ADDENDUM No.3

00 42 13 **PROPOSAL FOR SUFC PROJECT NO. 291029-04 Entitled "Rehab Natural Sciences Building – Bookstore Surge" at Purchase College, State University of New York**

2 UPPER LEVEL FINISH PLAN
Scale: 1/8" = 1'-0"

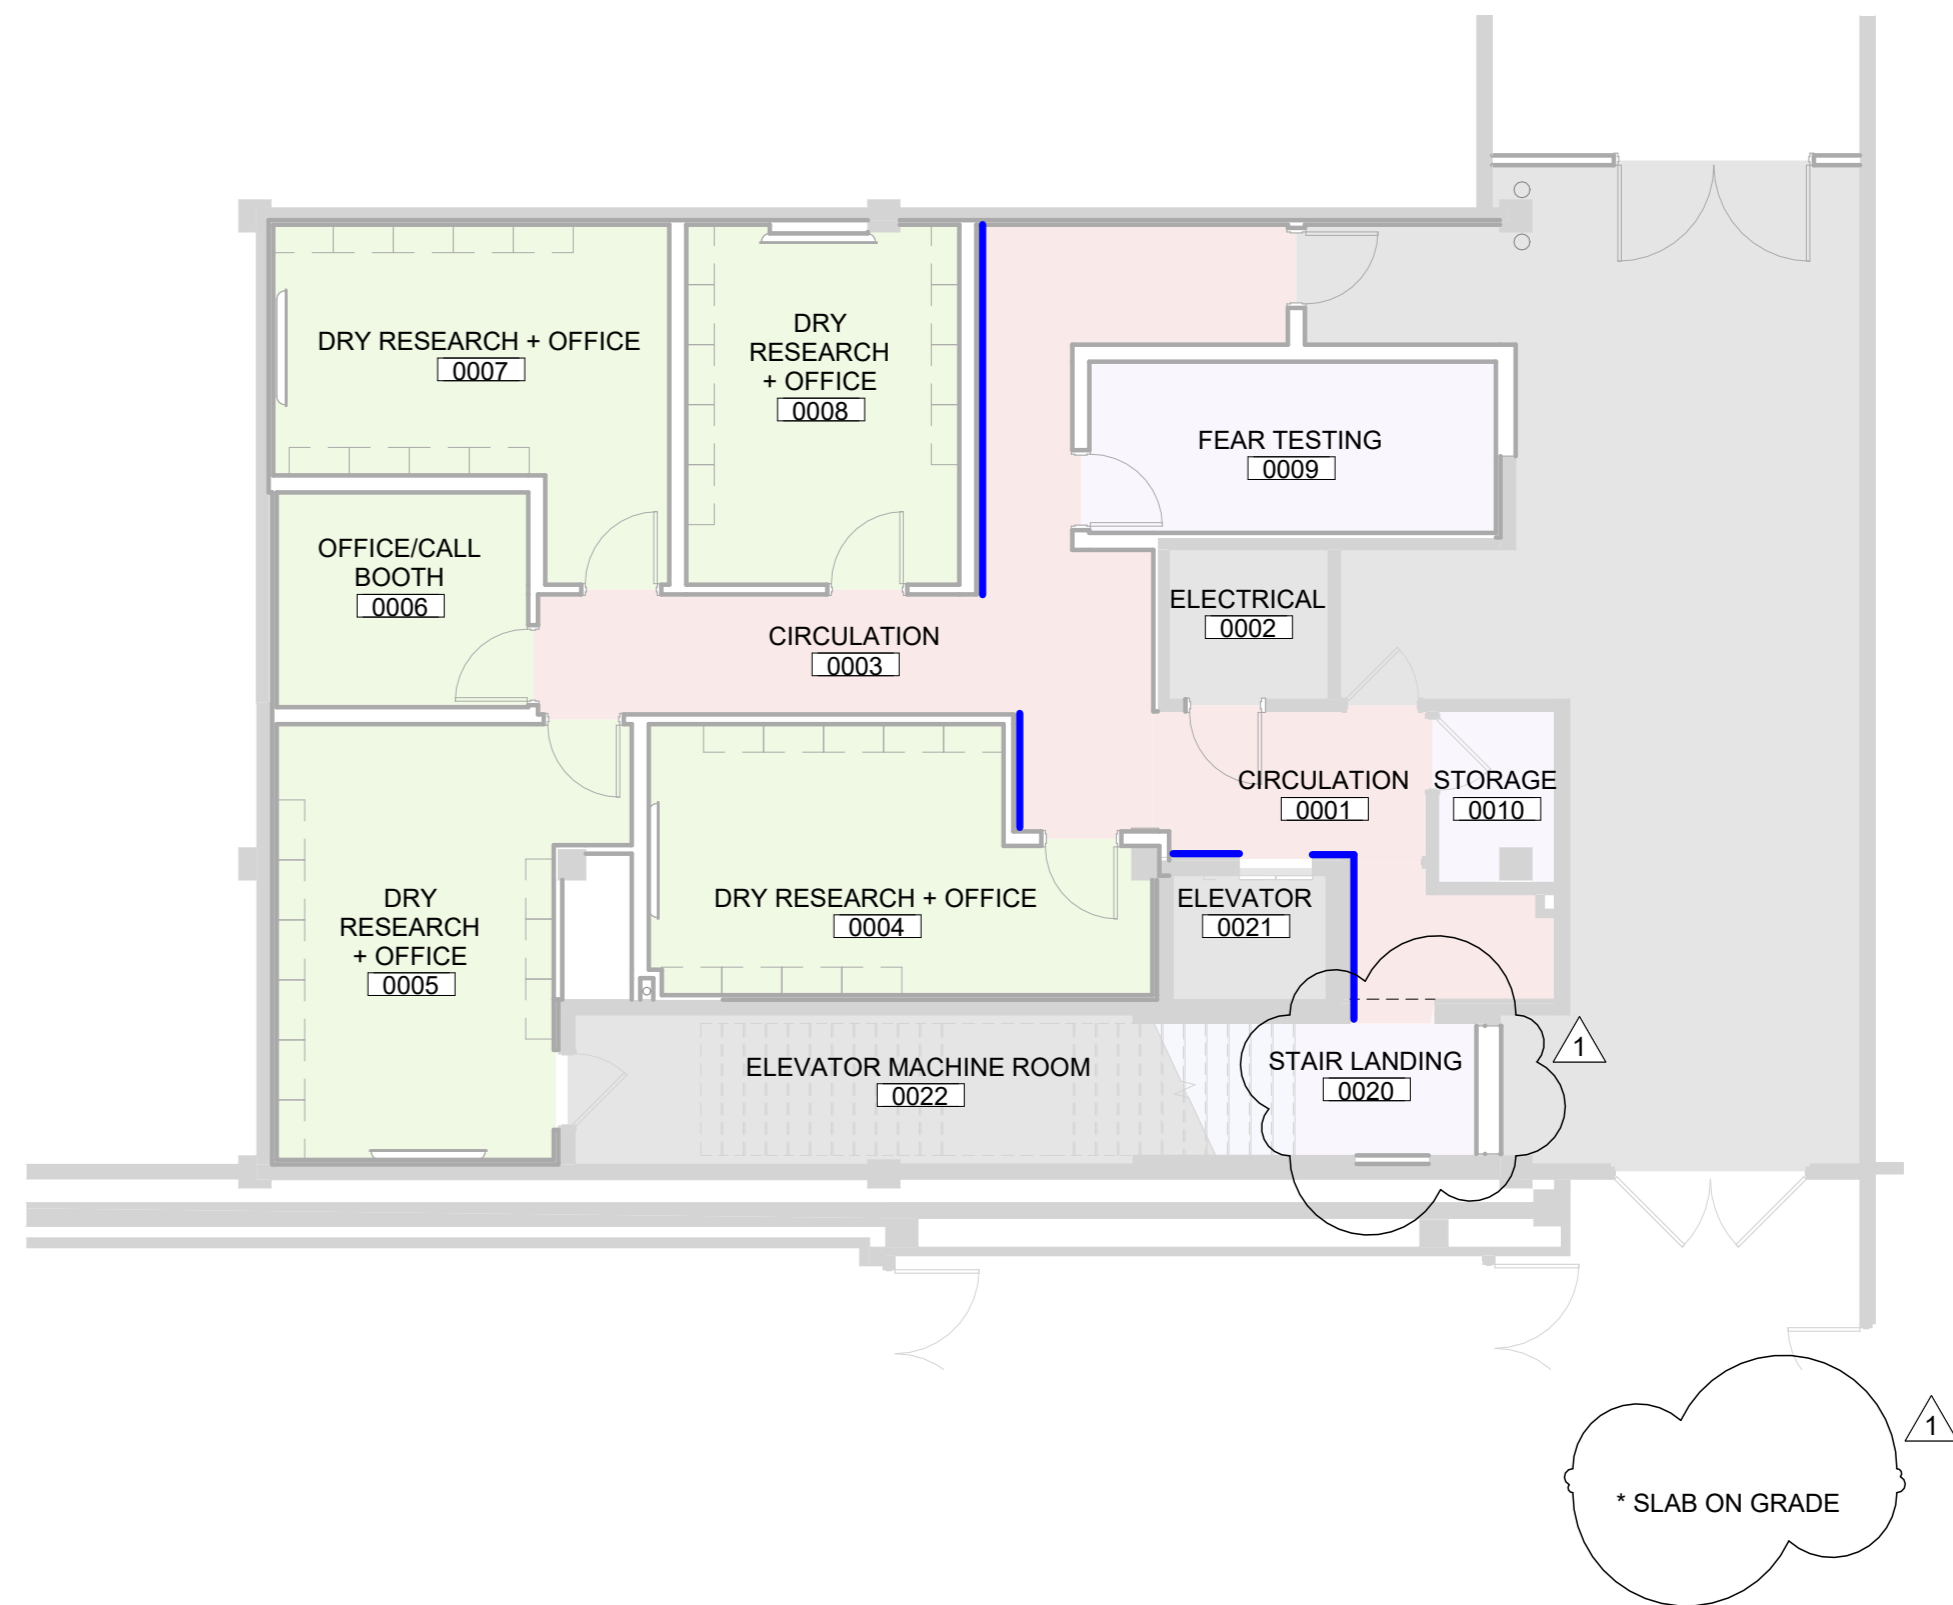
Drawing 2 revised to show RSF-1 at Stair Landing 1001D. Note added – “Elevated Slab”

1 LOWER LEVEL FINISH PLAN
Scale: 1/8" = 1'-0"

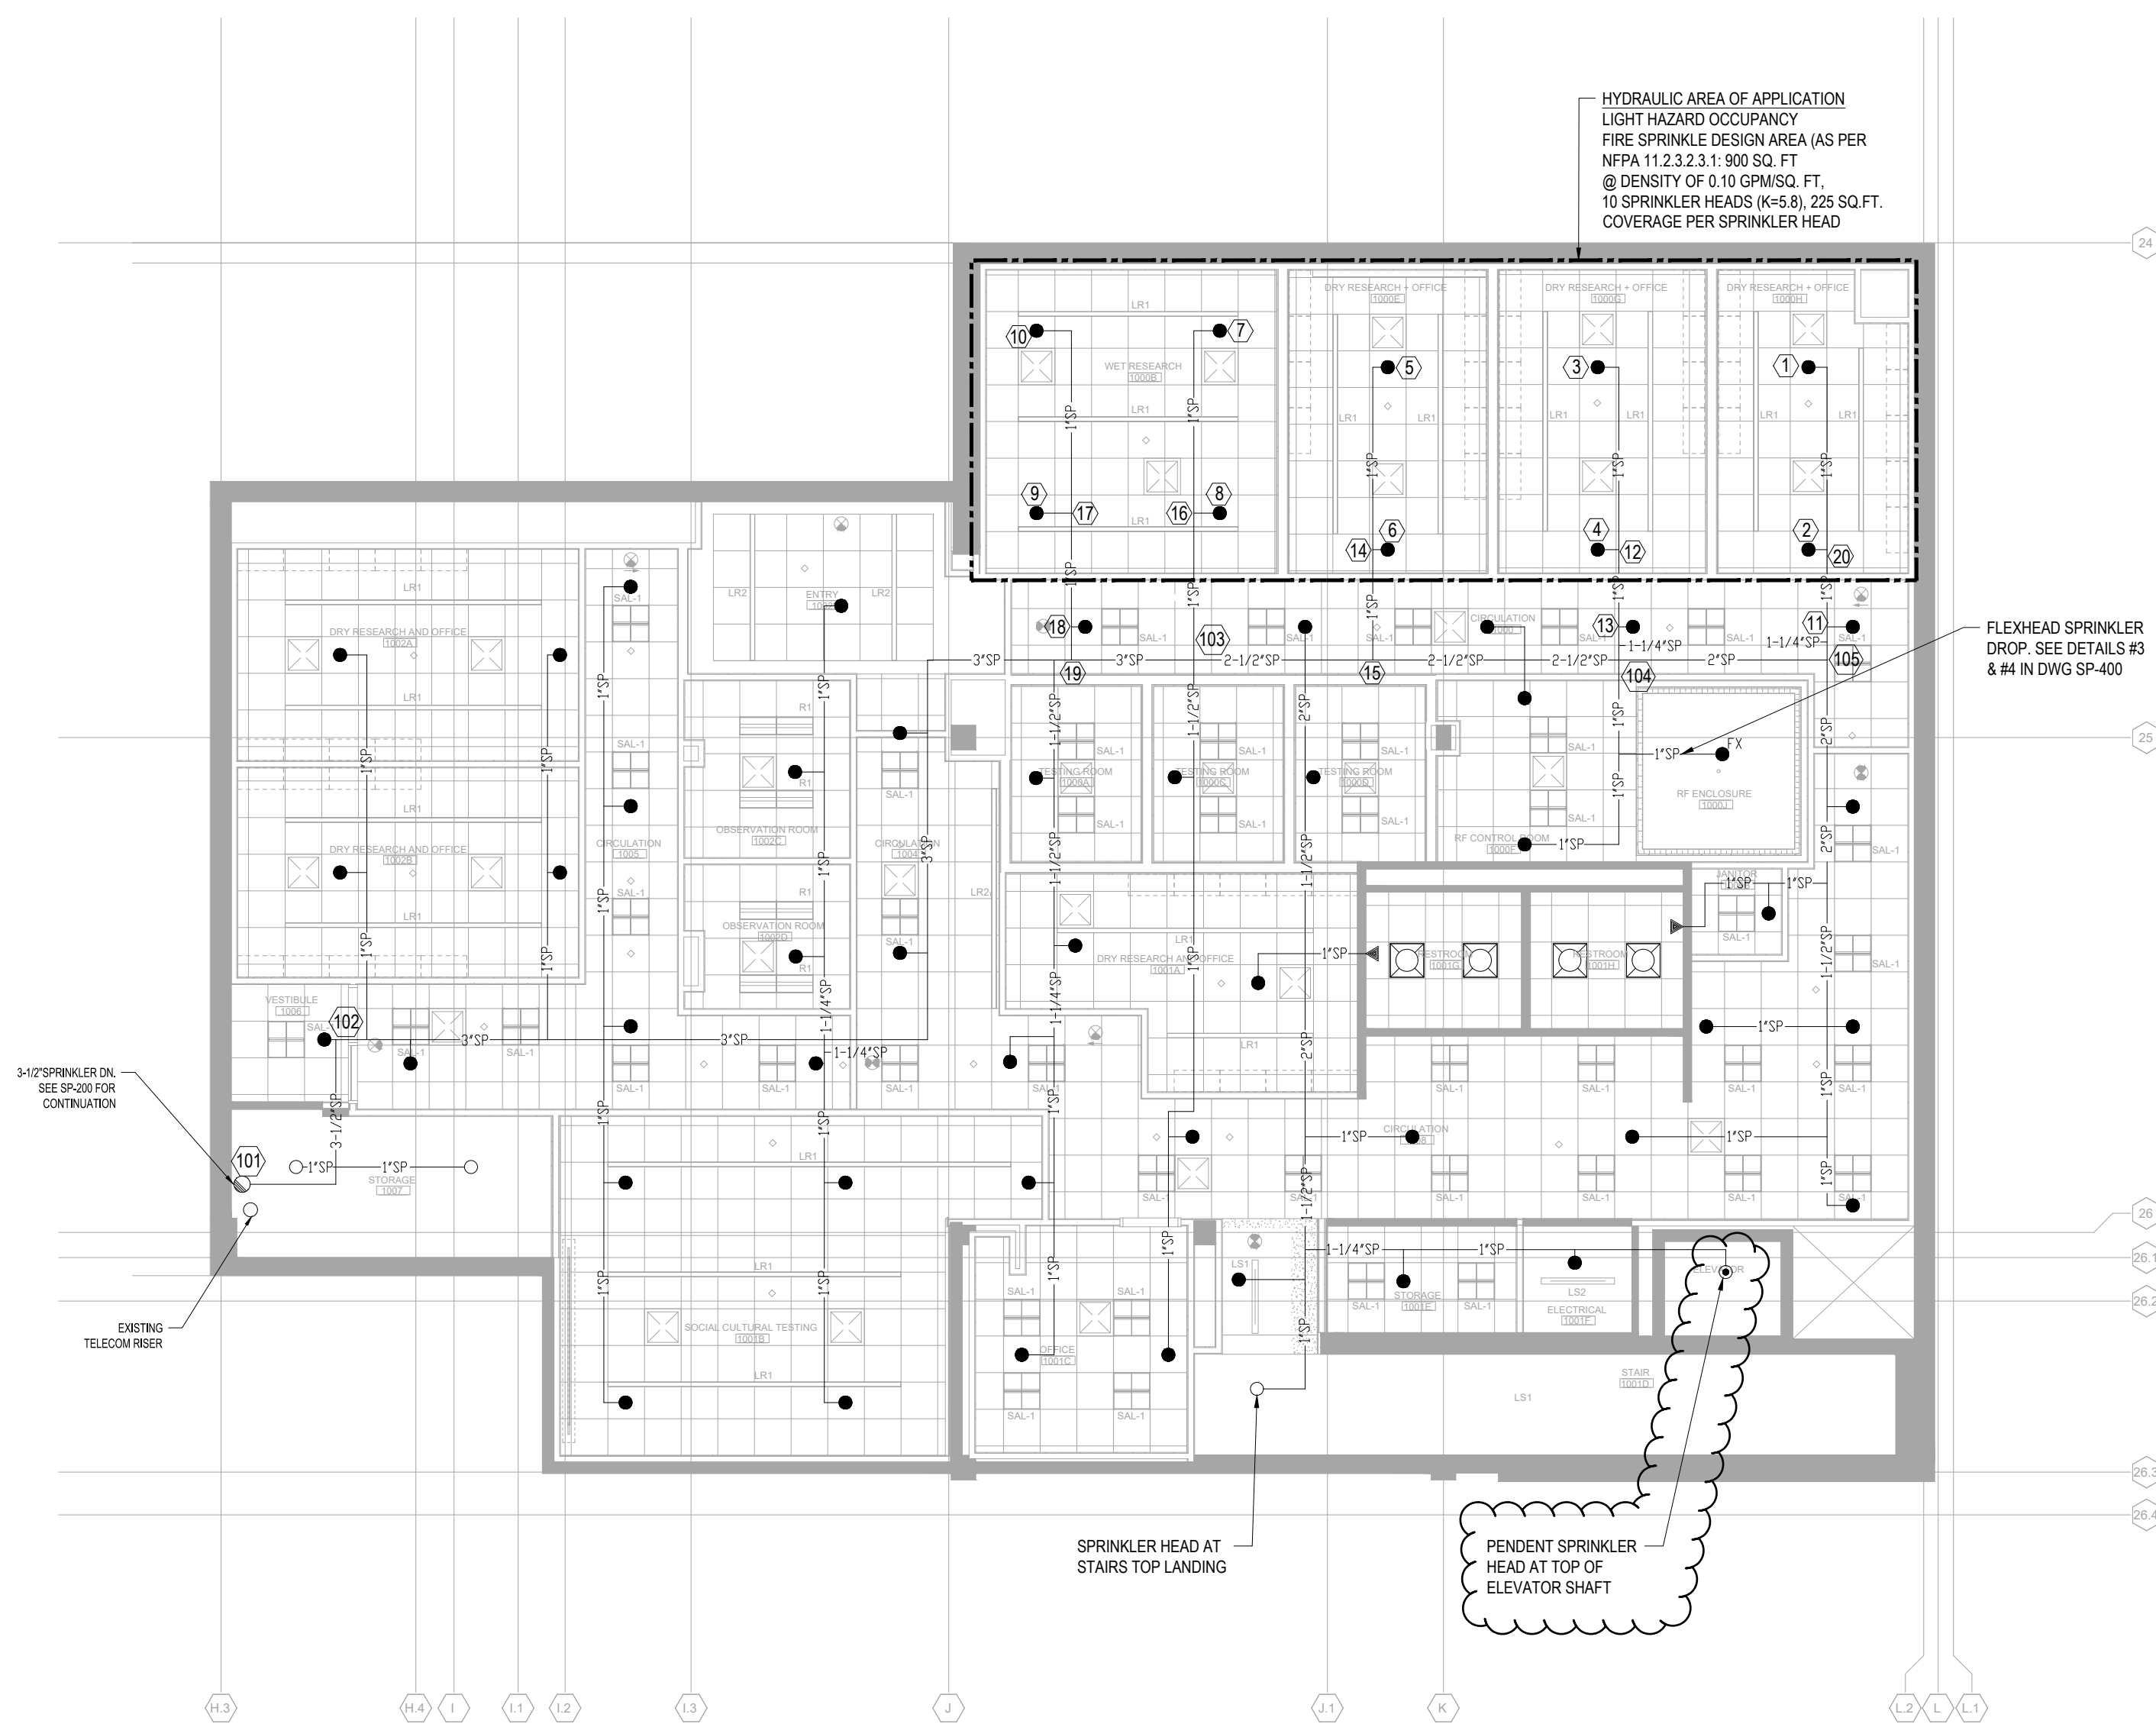
Drawing 1 revised to show RSF-1 at Stair Landing 0020. Note added – “Slab on Grade”.

1 SPRINKLER - UPPER LEVEL PART PLAN NEW WORK
Scale: 1/8" = 1'-0"

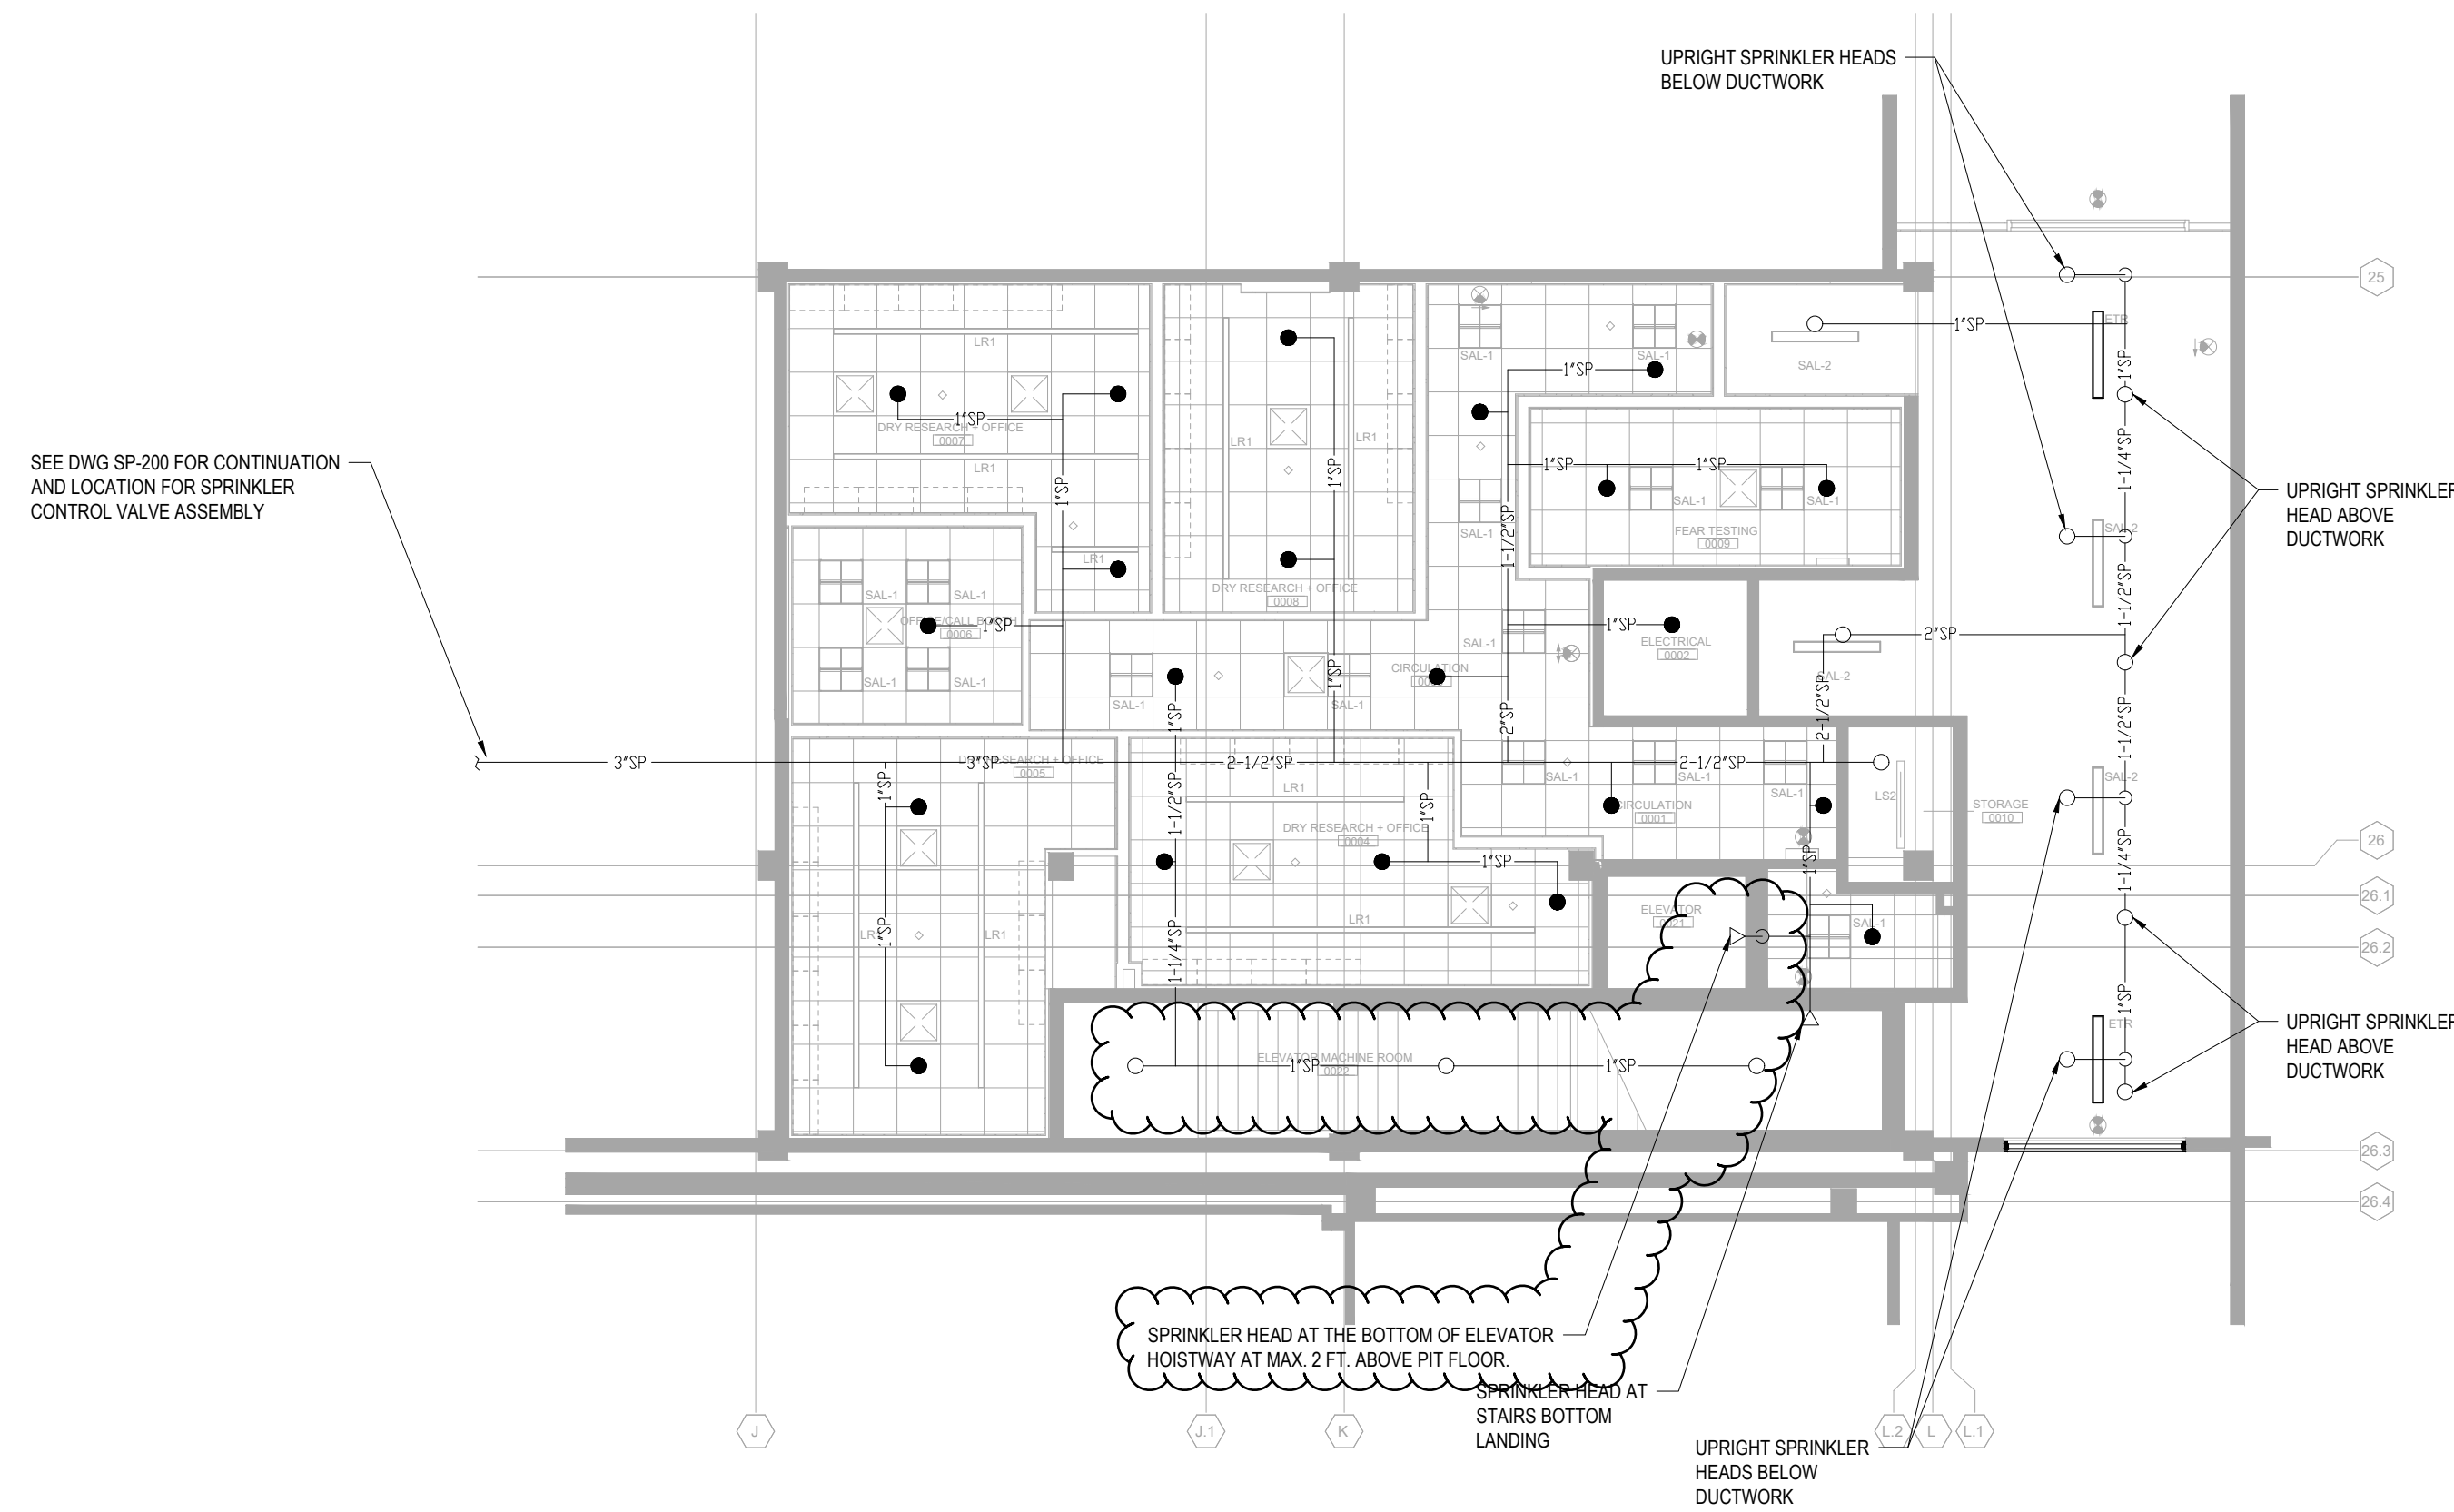
Item 016 Sheet SP-201

Drawing 1 revised to add a sprinkler head at the top of the elevator shaft

Drawing 2 revised to add a sprinkler head at the bottom of the elevator shaft
